February 17, 2020

ADDENDUM No. 1

**LUC-SEAMAN ROAD & YARROW STREET BRIDGE REPLACEMENTS
PID 107148**

**CITY OF OREGON
DEPARTMENT OF PUBLIC SERVICE**

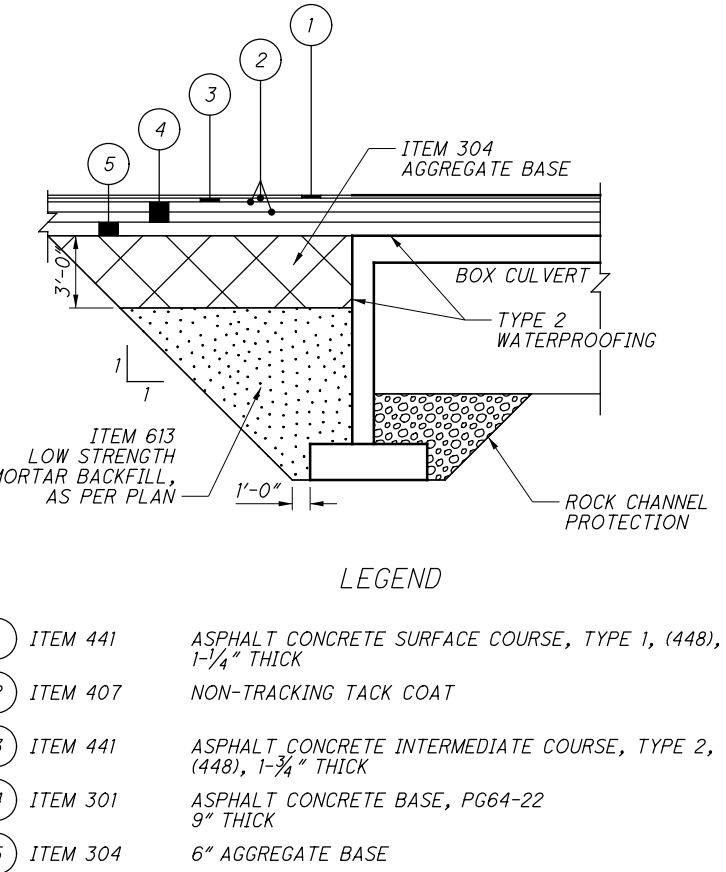
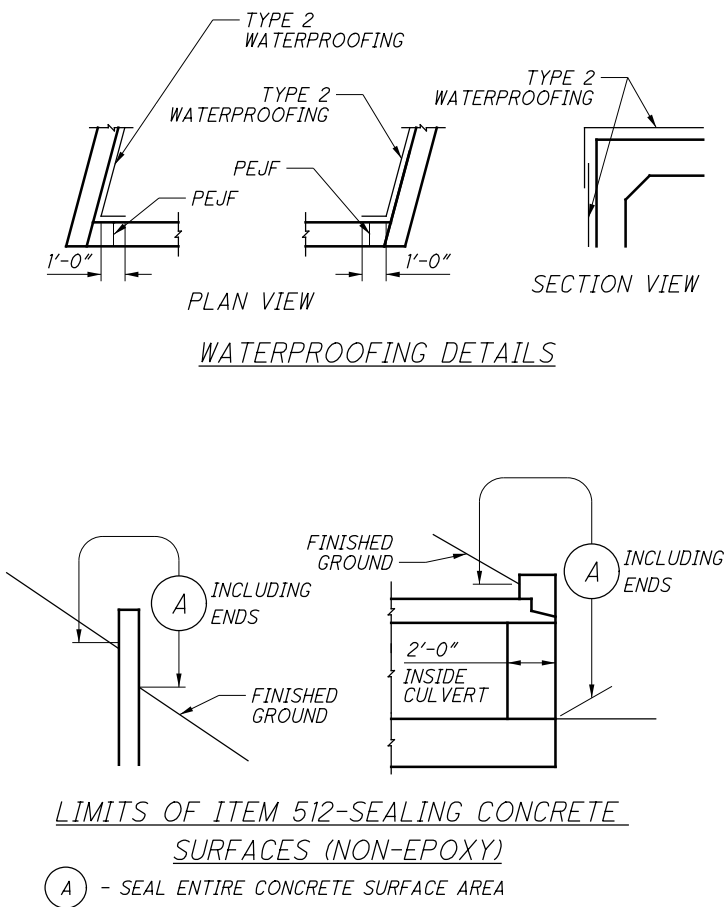
Replace PLAN SHEETS 43 and 50 in the Plan Set with the attached **REVISED PLAN SHEETS 43 and 50 DATED 2/13/20**.

1 - 2/13/20 FILTER MATERIAL REMOVED FROM ITEM

GENERAL NOTES
YARROW STREET BRIDGE
OVER THE OTTER CREEK

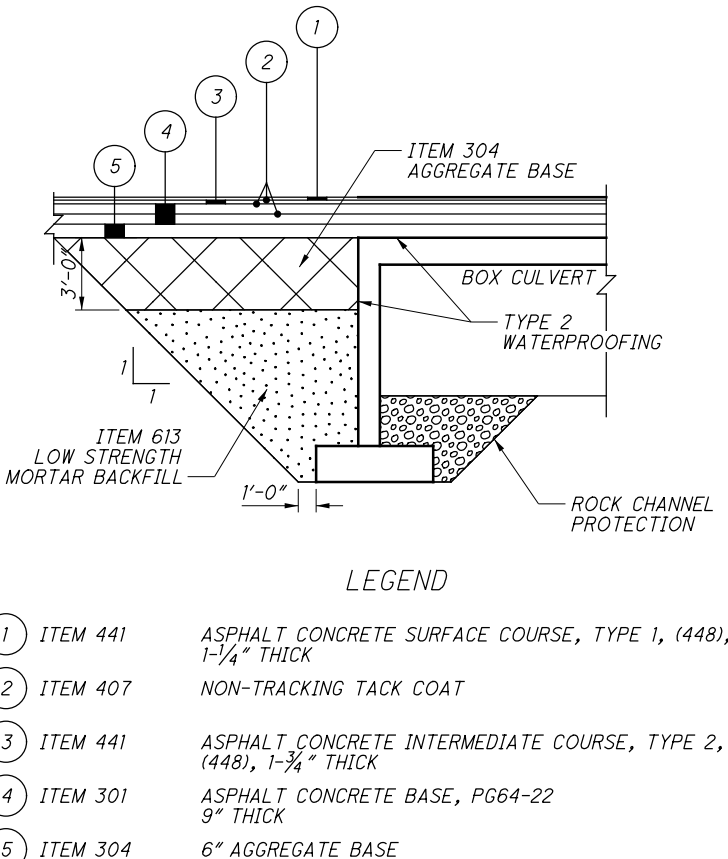
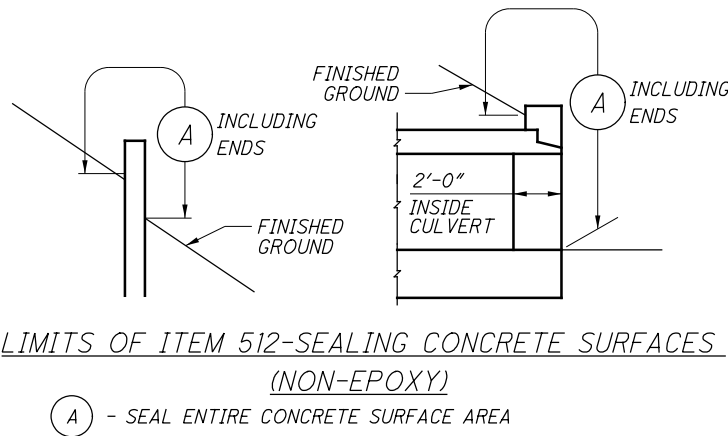
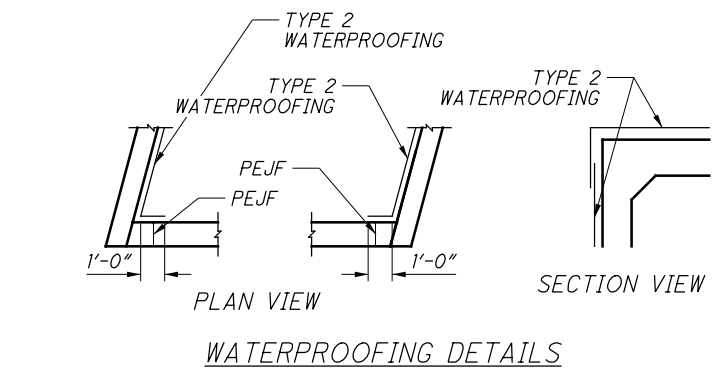
1 - 2/13/20 FILTER MATERIAL REMOVED FROM ITEM
